**Center for Advanced
Aviation System Development**

Nuevo Aeropuerto Internacional de la Ciudad de México Preliminary Airspace Redesign

Informal Working Notes on Departure Procedures

30 June 2016

Figure A-1. NAICM RNAV SID: Runway 2 Land North (NAICM_SID_EN_Land_North_R2)

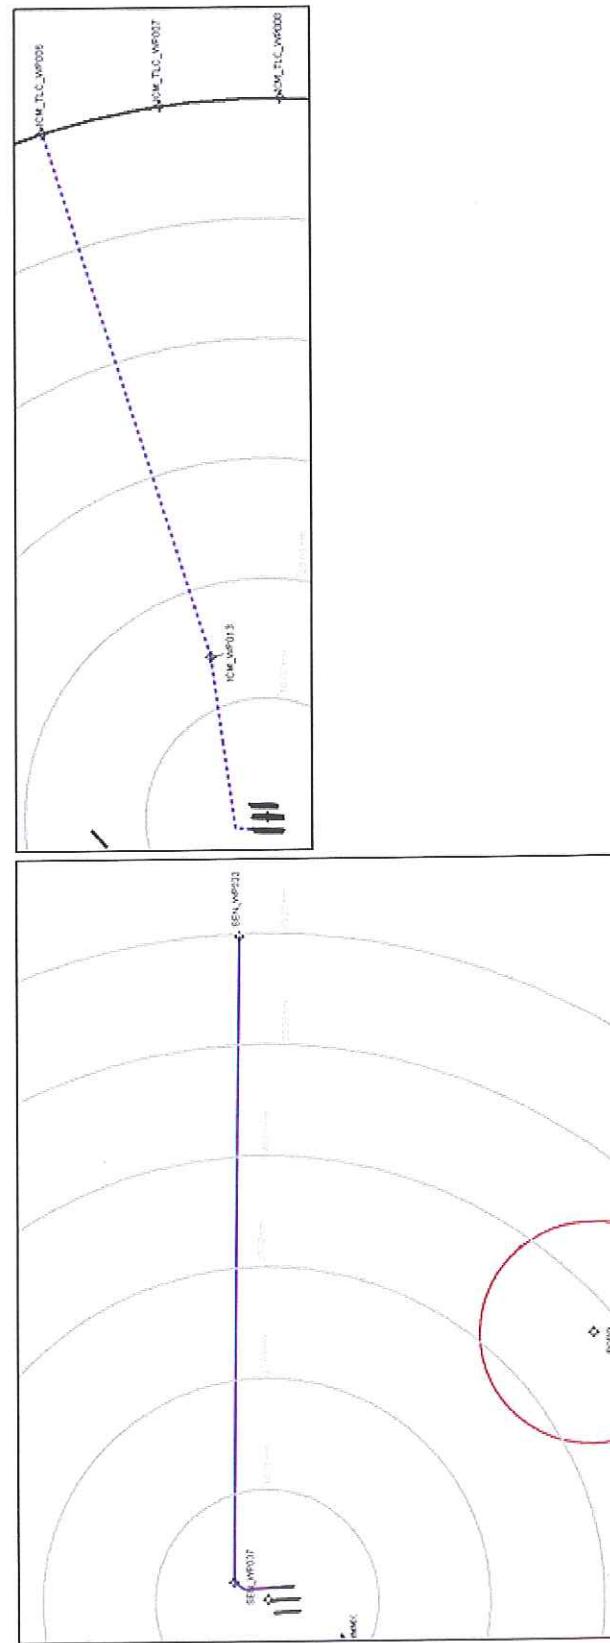
SENEAM and MITRE agreed to create three exit fixes on the eastern TMA boundary at a 60 NM range from the NAICM reference point provided by SENEAM. The graphic on the right displays the location of all three fixes and their relative position to each other. The waypoint ICM_WP013 was added to restrict arrivals on downwind.

Figure A-2. NAICM RNAV SID: Runway 2 Land North (NAICM_SID_E_Land_North_R2)

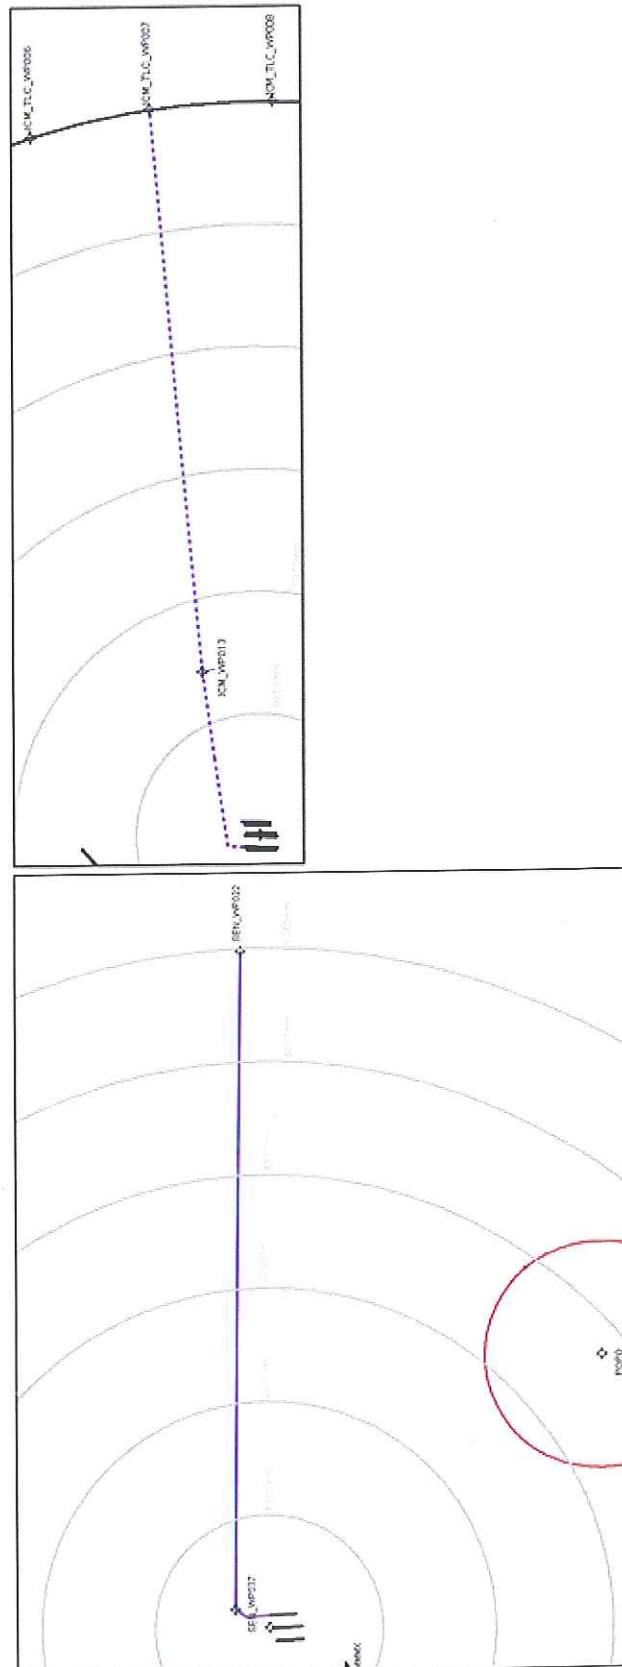
SENEAM and MITRE agreed to create three exit fixes on the eastern TMA boundary at a 60 NM range from the NAICM reference point provided by SENEAM. The graphic on the right displays the location of all three fixes and their relative position to each other. The waypoint ICM_WP013 was added to restrict departures below the NAICM arrivals on downwind.

Figure A-3. NAICM RNAV SID: Runway 2 Land North (NAICM_SID_ES_Land_North_R2)

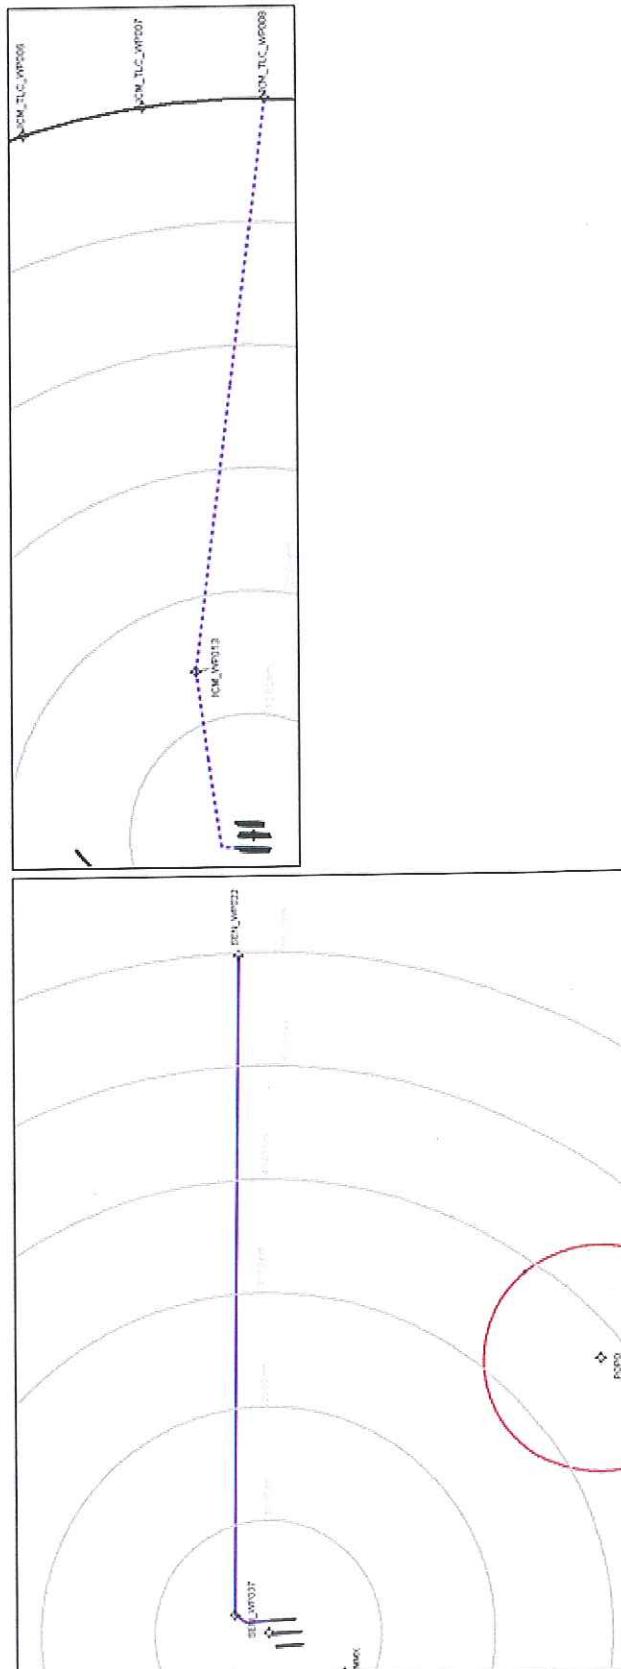
SENEAM and MITRE agreed to create three exit fixes on the eastern TMA boundary at a 60 NM range from the NAICM reference point provided by SENEAM. The graphic on the right displays the location of all three fixes and their relative position to each other. The waypoint ICM_WP013 was added to restrict departures below the NAICM arrivals on downwind.

Figure A-4. NAICM RNAV SID: Runway 2 Land North (NAICM_SID_SE_Land_North_R2)

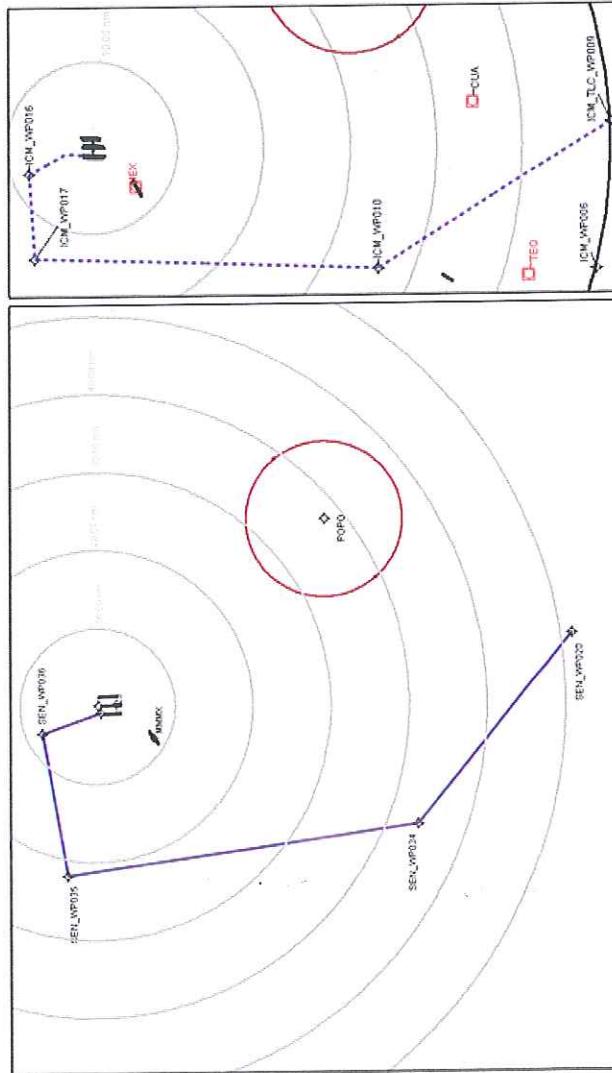
SENEAM and MITRE agreed to create two exit fixes on the southern TMA boundary at a 60 NM range from the NAICM reference point provided by SENEAM. The graphic on the right displays the location of both fixes and their relative position to each other. The departure initially diverges by 30 degrees from runway heading. At waypoint ICM_WP017, the departures are deconflicted from the NAICM downwind traffic and can then climb unrestricted. At waypoint ICM_WP010, the aircraft will be above the NAICM arrival traffic from the southwest.

Figure A-5. NAICM RNAV SID: Runway 2 Land North (NAICM_SID_SE_Land_North_R2_A15)

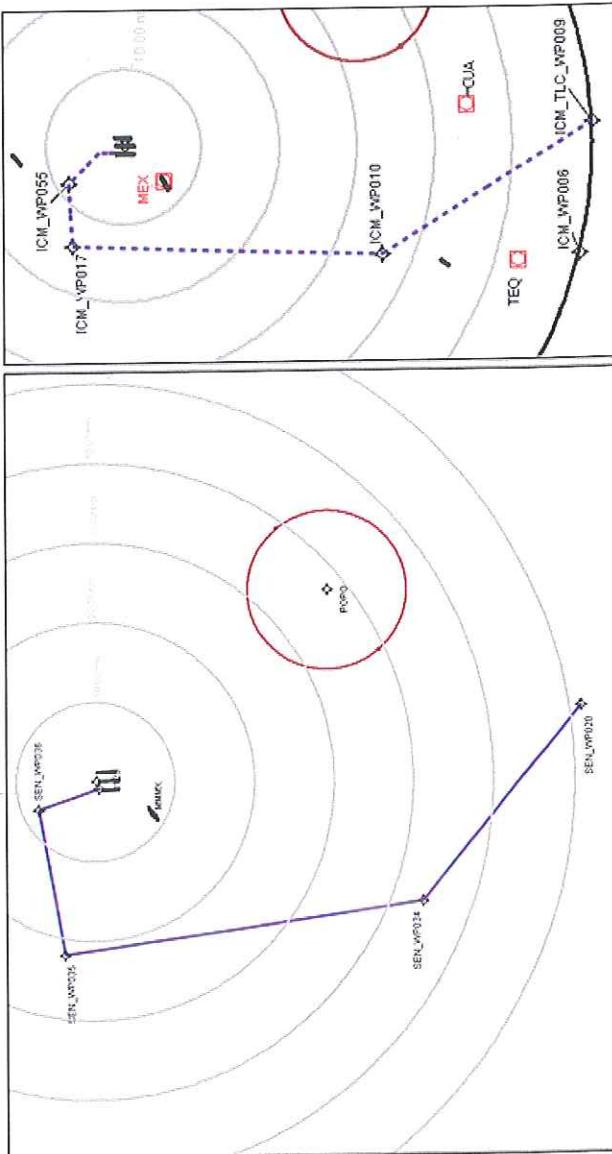
SENEAM and MITRE agreed to create two exit fixes on the southern TMA boundary at a 60 NM range from the NAICM reference point provided by SENEAM. The graphic on the right displays the location of both fixes and their relative position to each other. The departure initially diverges by 45 degrees from runway heading. At waypoint ICM_WP017, the departures are deconflicted from the NAICM downwind traffic and can then climb unrestricted. At waypoint ICM_WP010, the aircraft will be above the NAICM arrival traffic from the southwest. This is an alternate design that is offset by 15 degrees from the original design, NAICM_SID_SE_Land_North_R2, shown in Figure A-4.

Figure A-6. NAICM RNAV SID: Runway 2 Land North (NAICM_SID_SE_Land_North_R2_A45)

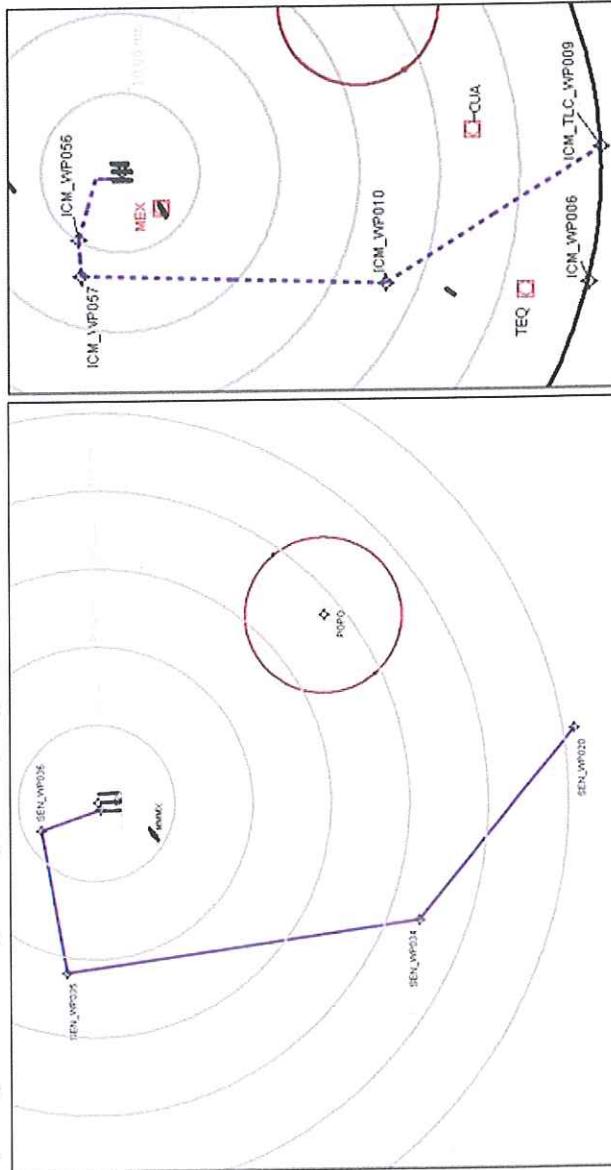
SENEAM and MITRE agreed to create two exit fixes on the southern TMA boundary at a 60 NM range from the NAICM reference point provided by SENEAM. The graphic on the right displays the location of both fixes and their relative position to each other. The departure initially diverges by 75 degrees from runway heading. At waypoint ICM_WP037, the departures are deconflicted from the NAICM downwind traffic and can then climb unrestricted. At waypoint ICM_WP010, the aircraft will be above the NAICM arrival traffic from the southwest. This is an alternate design that is offset by 45 degrees from the original design, NAICM_SID_SE_Land_North_R2, shown in Figure A-4.

Figure A-7. NAICM RNAV SID: Runway 2 Land North (NAICM_SID_SW_Land_North_R2)

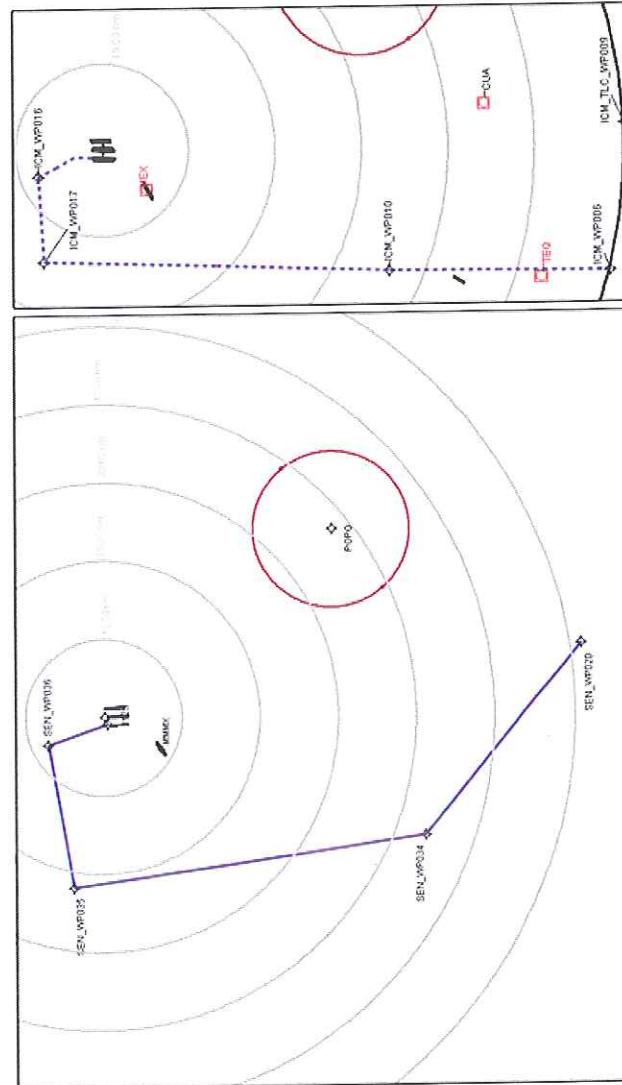
SENEAM and MITRE agreed to create two exit fixes on the southern TMA boundary at a 60 NM range from the NAICM reference point provided by SENEAM. The graphic on the right displays the location of both fixes and their relative position to each other. The departure initially diverges by 30 degrees from runway heading. At waypoint ICM_WP017, the departures are deconflicted from the NAICM downwind traffic and can then climb unrestricted. At waypoint ICM_WP010, the aircraft will be above the NAICM arrival traffic from the southwest.

Figure A-8. NAICM RNAV SID: Runway 2 Land North (NAICM_SID_SW_Land_North_R2_A15)

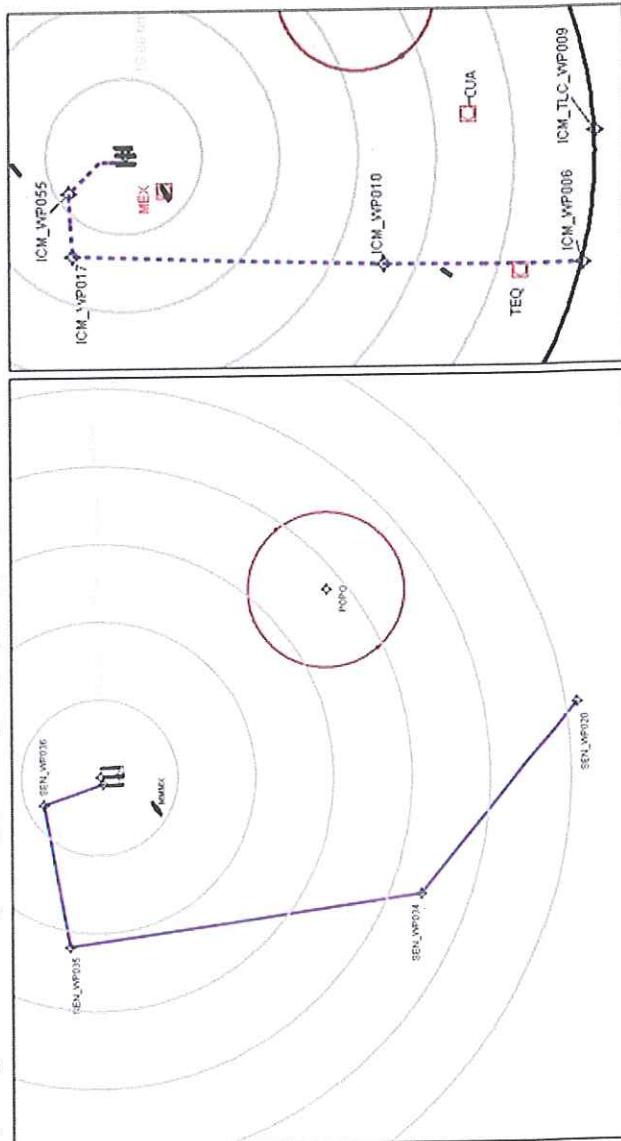
SENEAM and MITRE agreed to create two exit fixes on the southern TMA boundary at a 60 NM range from the NAICM reference point provided by SENEAM. The graphic on the right displays the location of both fixes and their relative position to each other. The departure initially diverges by 45 degrees from runway heading. At waypoint ICM_WP017, the departures are deconflicted from the NAICM downwind traffic and can then climb unrestricted. At waypoint ICM_WP010, the aircraft will be above the NAICM arrival traffic from the southwest. This is an alternate design that is offset by 15 degrees from the original design, NAICM_SID_SW_Land_North_R2, shown in Figure A-7.

Figure A-10. NAICM RNAV SID: Runway 2 Land North (NAICM_SID_W_Land_North_R2)

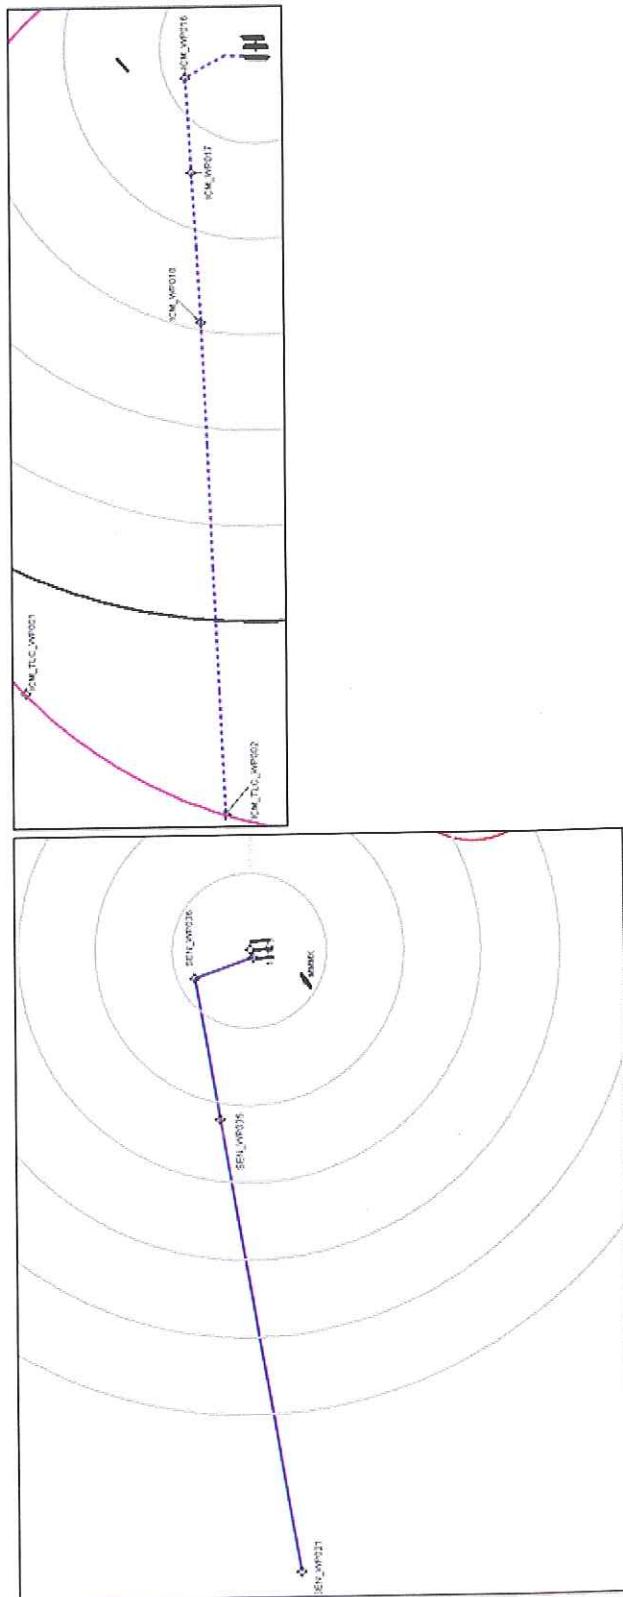
SENEAM and MITRE agreed to create two exit fixes on the western TMA boundary. Both fixes are located at a 50 NM range from the Toluca VOR (TLC). The graphic on the right displays the location of both fixes and their relative position to each other. The departure initially diverges by 30 degrees from runway heading. At waypoint ICM_WP017, the departures are deconflicted from the NAICM downwind traffic and can then climb unrestricted.

Figure A-11. NAICM RNAV SID: Runway 2 Land North (NAICM_SID_W_Land_North_R2_A15)

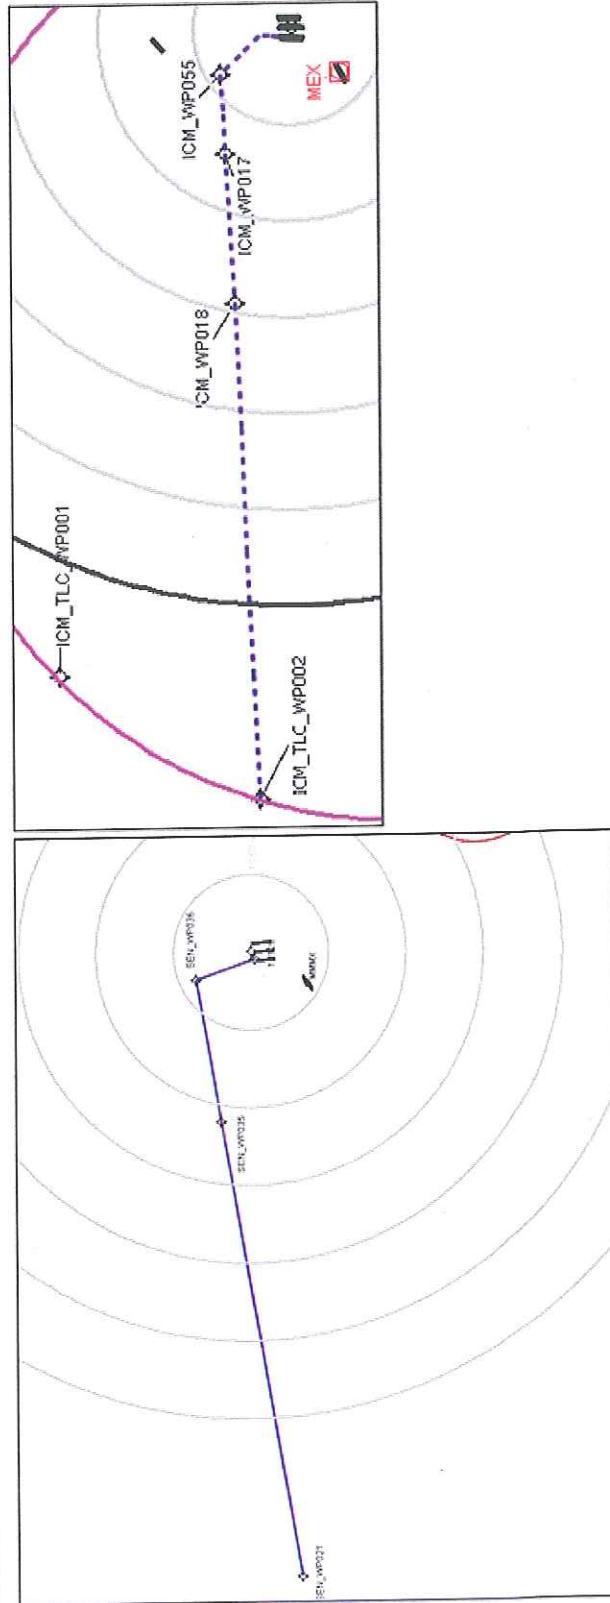
SENEAM and MITRE agreed to create two exit fixes on the western TMA boundary. Both fixes are located at a 50 NM range from the Toluca VOR (TLC). The graphic on the right displays the location of both fixes and their relative position to each other. The departure initially diverges by 15 degrees from runway heading. At waypoint ICM_WP017, the departures are deconflicted from the NAICM downwind traffic and can then climb unrestricted. This is an alternate design that is offset by 15 degrees from the original design, NAICM_SID_W_Land_North_R2, shown in Figure A-10.

Figure A-12. NAICM RNAV SID: Runway 2 Land North (NAICM_SID_W_Land_North_R2_A45)

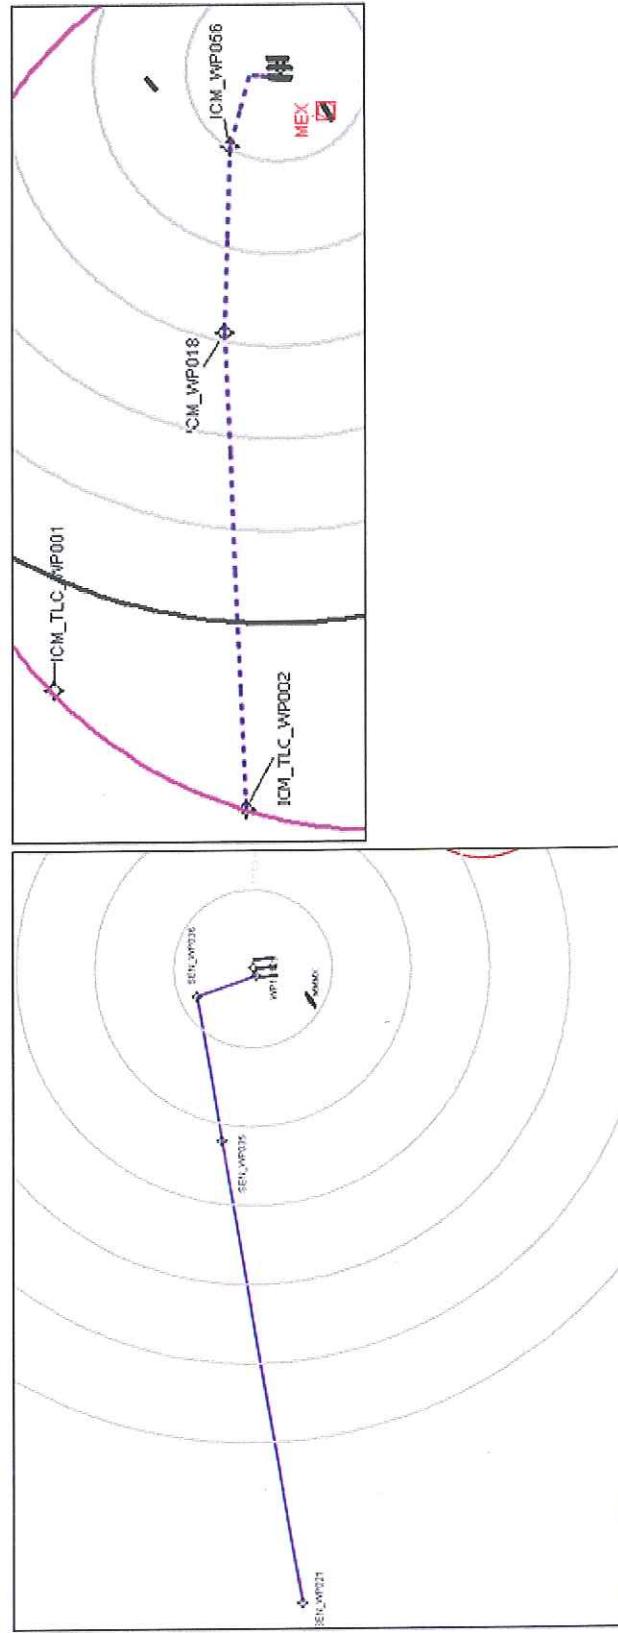
SENEAM and MITRE agreed to create two exit fixes on the western TMA boundary. Both fixes are located at a 50 NM range from the Toluca VOR (TLC). The graphic on the right displays the location of both fixes and their relative position to each other. The departure initially diverges by 75 degrees from runway heading. At waypoint ICM_WP018, the departures are deconflicted from the NAICM downwind traffic and can then climb unrestricted. This is an alternate design that is offset by 45 degrees from the original design, NAICM SID_W_Land_North_R2, shown in Figure A-10.
